# SERVICE SLANTS

Micro Switches for Model 1250 Tone Arms

1217

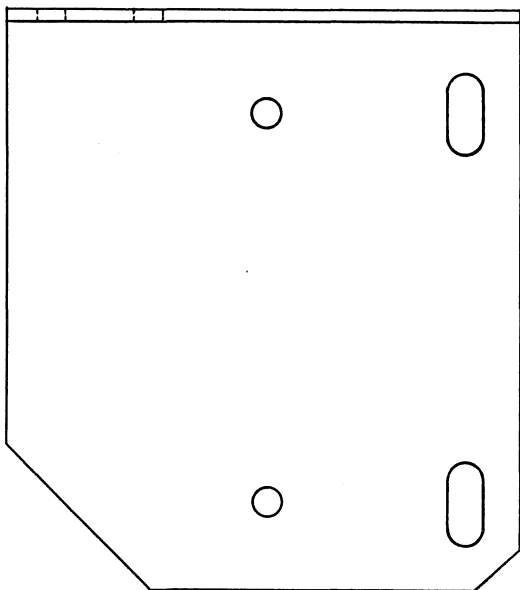
A Mounting Bracket is available for purpose of installing two Micro Switches in the Model 1250 tone arms circuit. This may be ordered as Part No. 54932.

This mounting bracket is designed to accomodate two (2) Micro Switches as are used for the Reverse Switch, Part No. 53809. This is a single pole, double throw, switch and in this application use only the normally open side of each switch. This will be affixed to Record Changer in same position occupied by the No. 53257 Switch Assembly.

Two slotted holes in the bracket permit positioning switches for good contact and with a normal amount of over travel in both the open and closed positions. This adjustment is made to comply with the travel of tone arm positioning shaft and pin assembly, Part No. 53755.

Where so desired these micro switches can be used as an alternate to replace present switch No. 53257 at current prices of parts indicated.
